Chapter 6

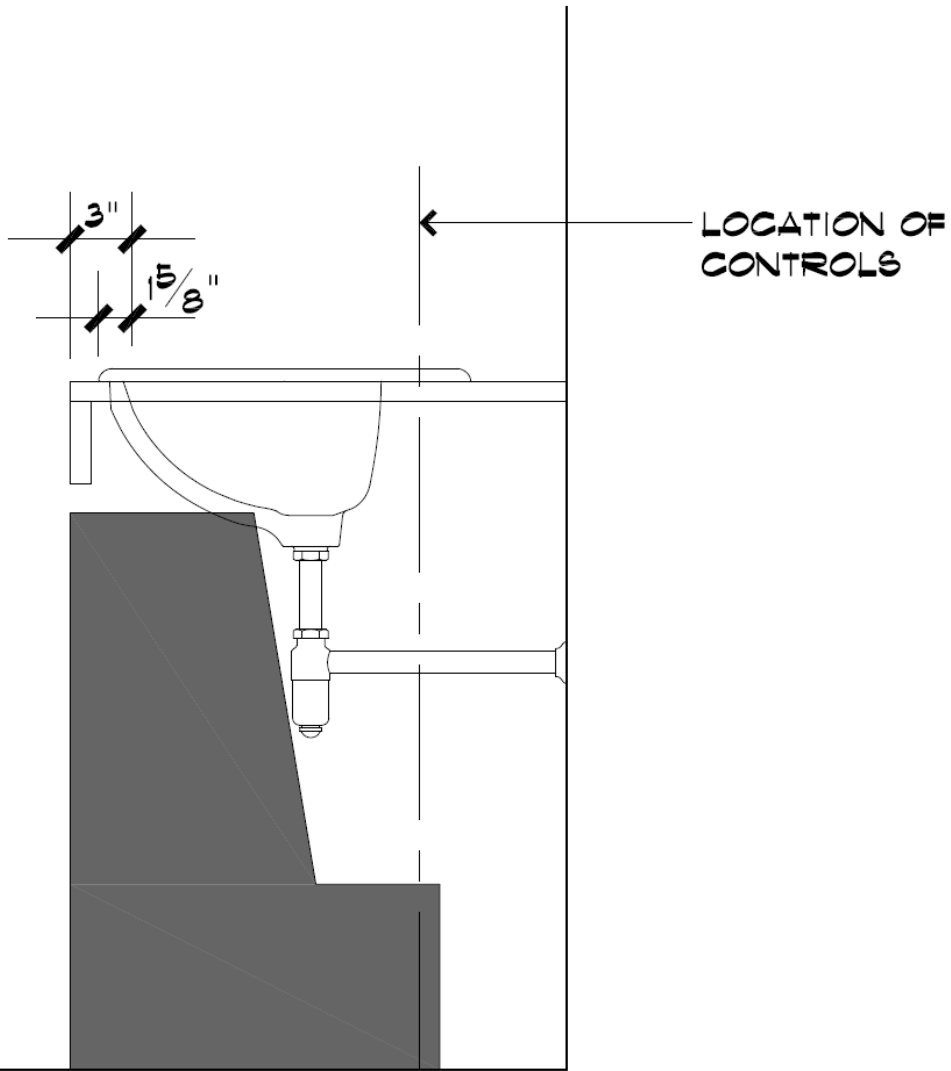
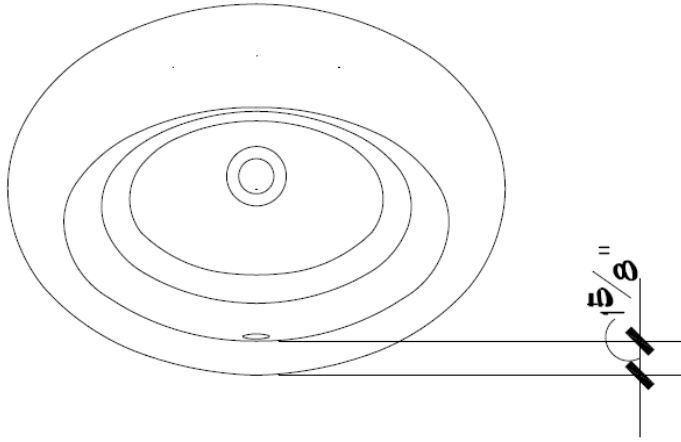
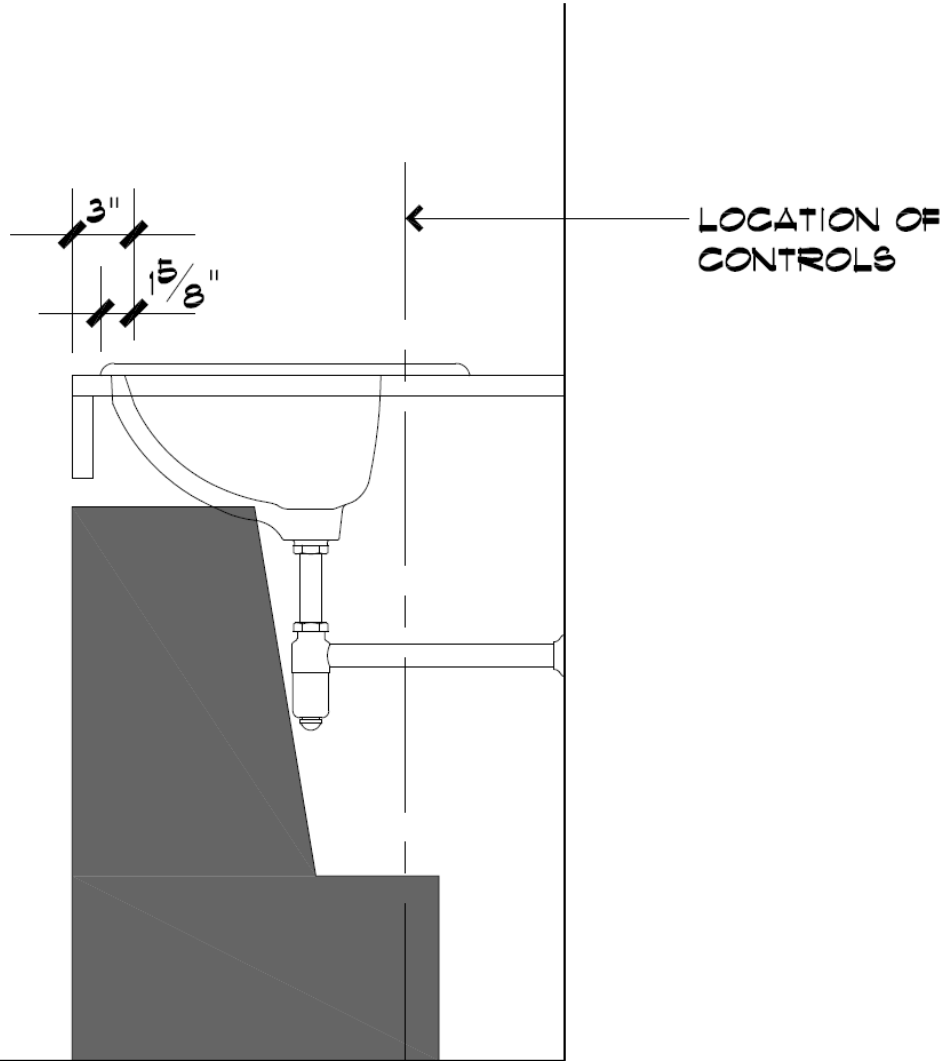
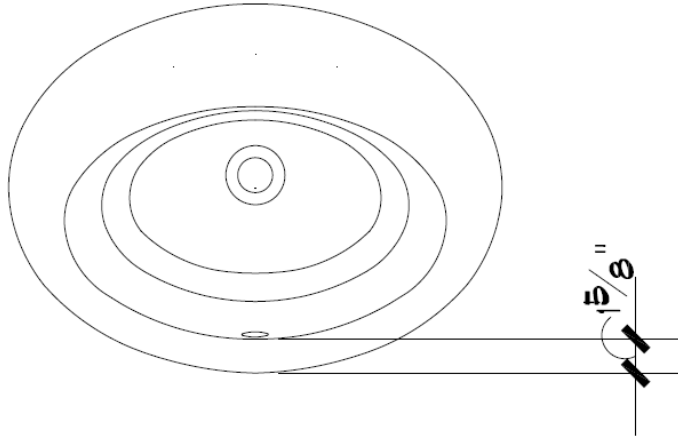
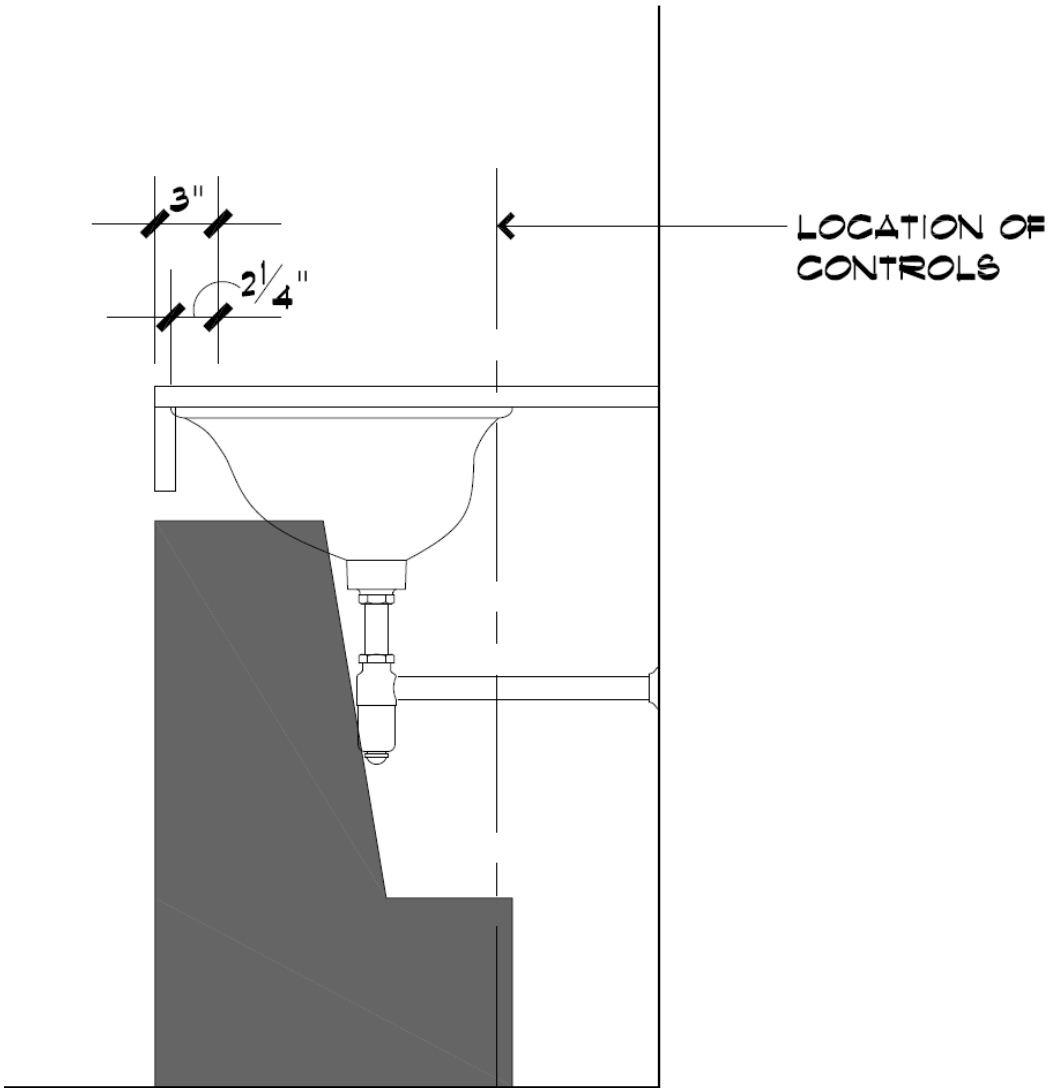
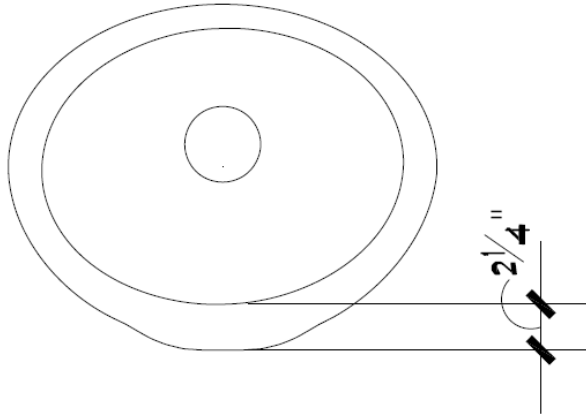
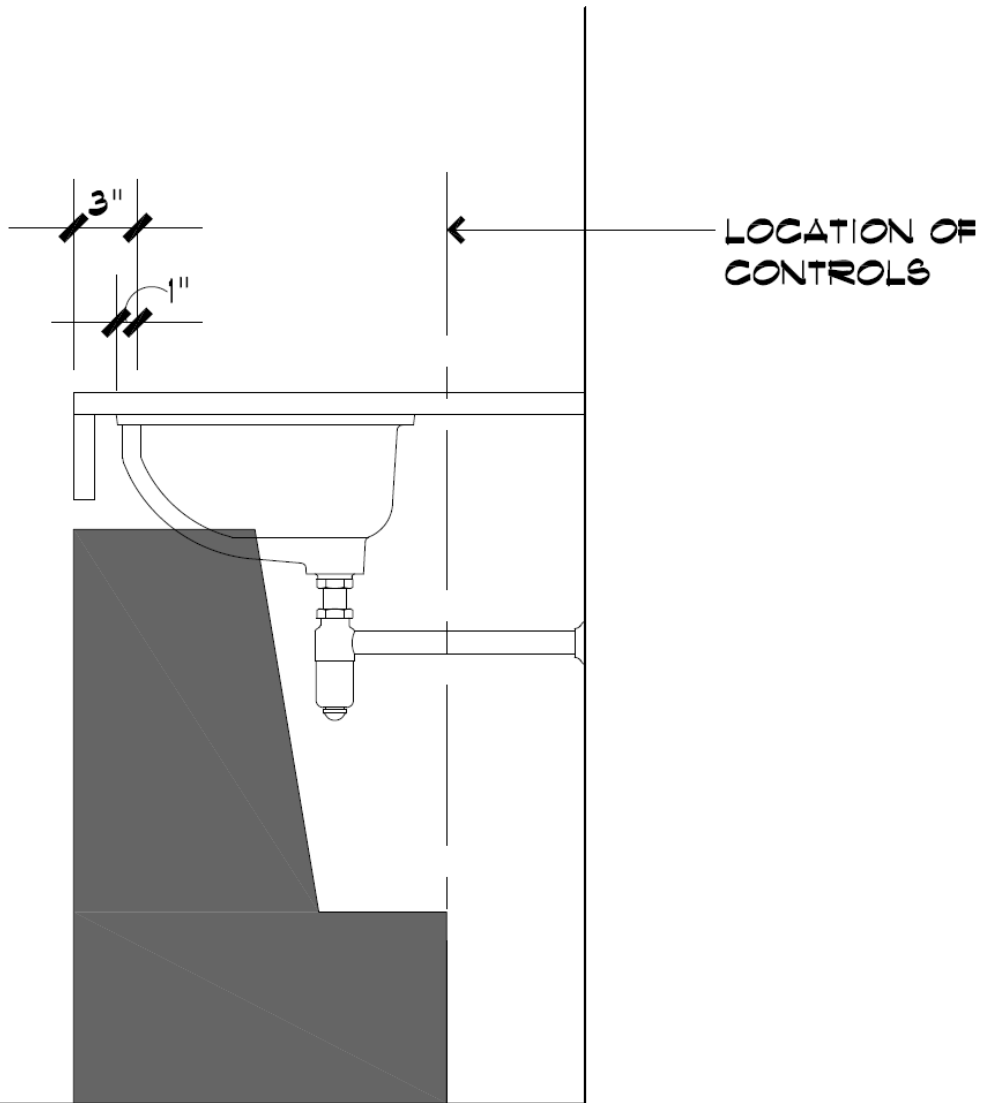
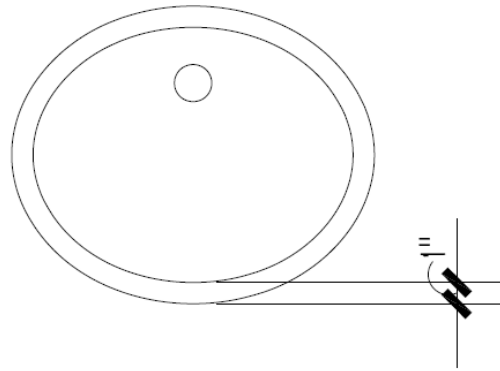
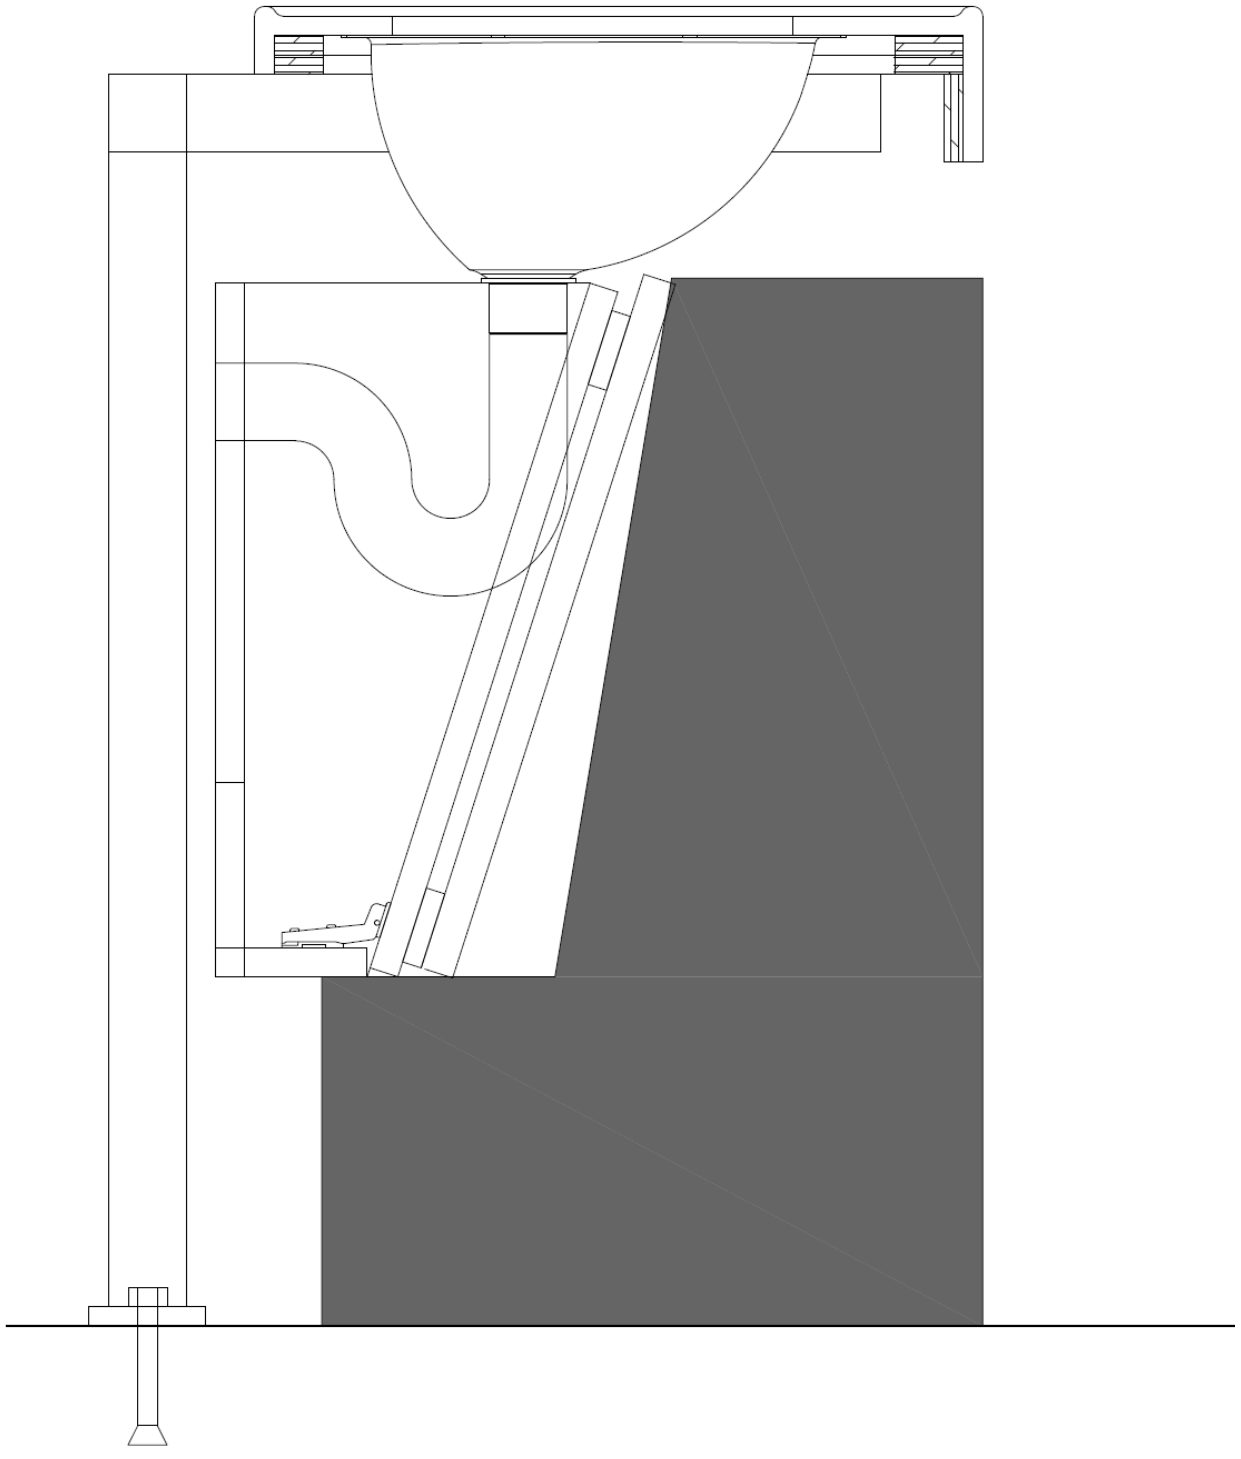
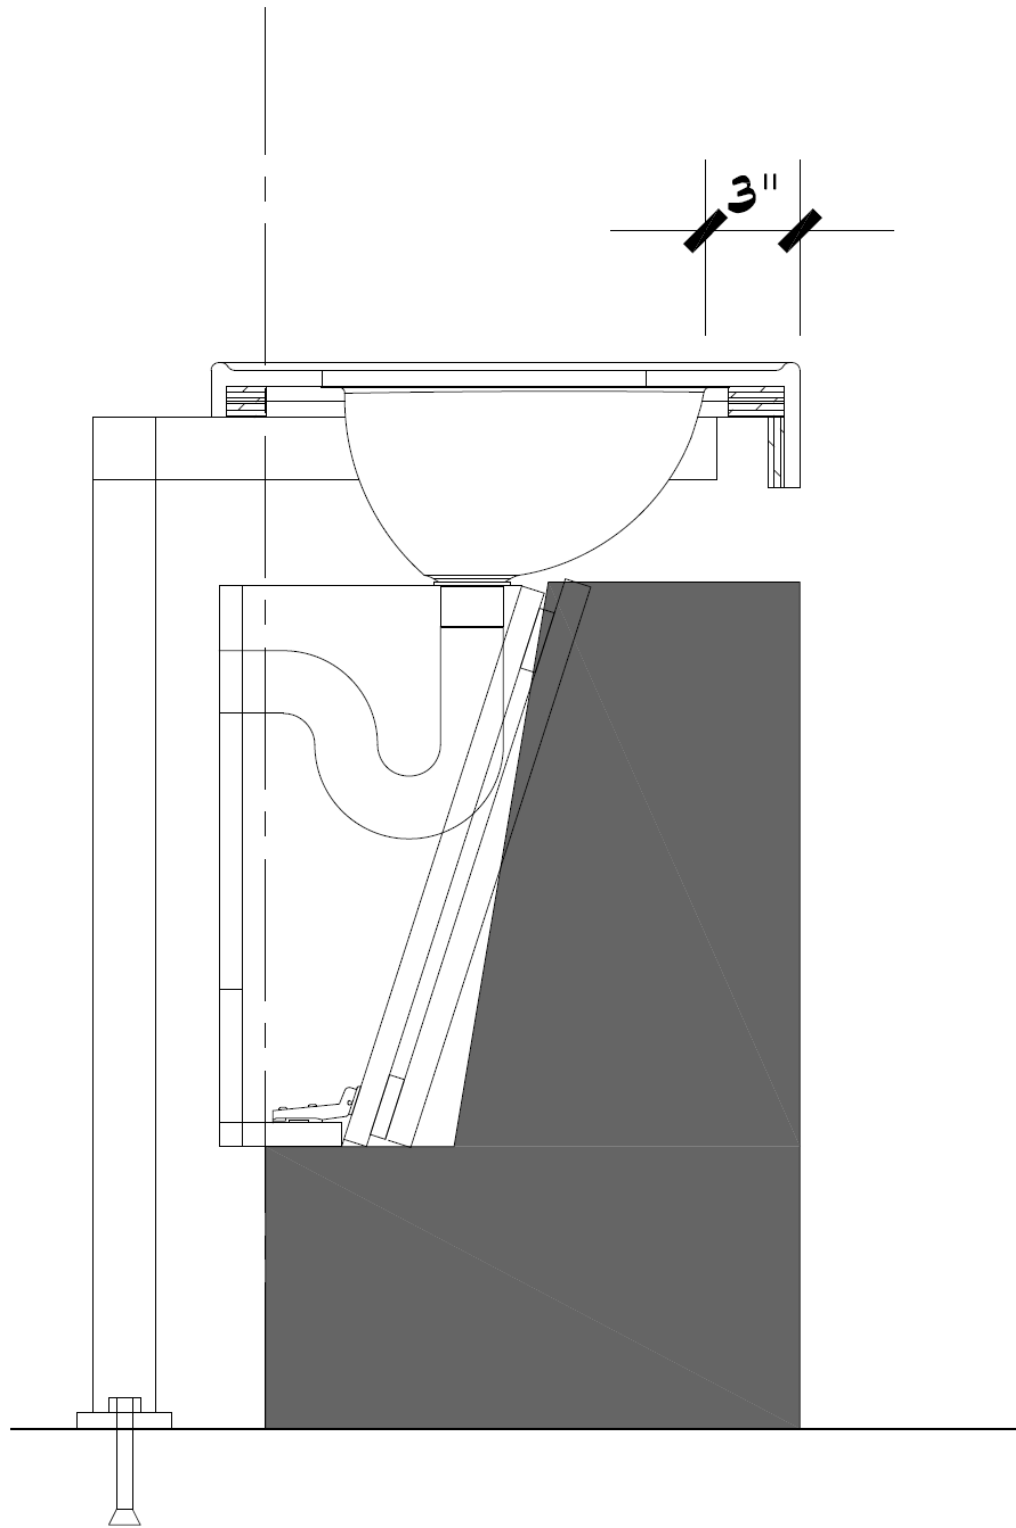
606.5 Basin Location. The interior edge of the rim of the lavatory basin shall be located 3 ½ inches (~~75~~ 90 mm) maximum from the front edge of the fixture or countertop.

Reason: At the current 3" the from the front edge most sinks would not be able to comply with the required knee clearance. It would be impossible to meet the 8" deep requirement.
